**Re: Comments on Post-Construction Vapor Intrusion Assessment**

- **Site Name:** Taylor Way and Alexander Avenue Fill Area (TWAFA)
- **Site Address:** 1514 Taylor Way E, Tacoma, Pierce County, WA
- **Facility/Site ID:** 1403183
- **Cleanup Site ID:** 4692
- **Agreed Order No.:** DE13921

Thank you for submitting the *Supplemental Post-Construction Vapor Intrusion Assessment* (report)<sup>1</sup> for our review. The Department of Ecology (Ecology) has the following comments on the report:

*Figure 1. Note exposed gravel around fire supply water pipes that allow a direct connection to subsurface soil vapor.*

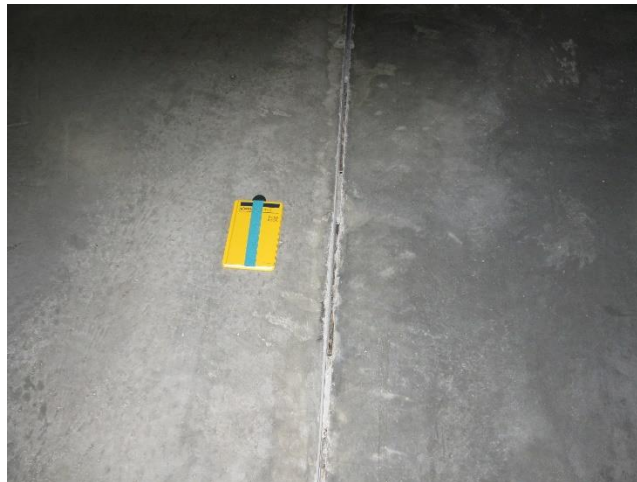
- b. **Chloroform in Indoor Air**: Concentrations of chloroform at indoor air locations IA-A1 and IA-A3 (1.3 and 1.9 micrograms per cubic meter,  $\mu\text{g}/\text{m}^3$ , respectively) exceeded the MTCA Method C air cleanup level of  $1.1 \mu\text{g}/\text{m}^3$ . The report attributes these exceedances to indoor sources. However, chloroform was measured in the sub-slab at concentrations up to  $1.6 \mu\text{g}/\text{m}^3$  and there are building features that could allow the direct transport of sub-slab soil gas into indoor air with little or no attenuation.

These features consist of the open penetration for the for the fire supply water lines in both buildings (Figure 1) and the wide expansion joint in Building A (Figure 2). To reduce the potential for chloroform vapor intrusion, the following actions shall be performed:

- i. The open penetrations shall be sealed around each of the fire supply lines in Buildings A and B.
- ii. Sealant shall be placed within the wide expansion joint in Building A.
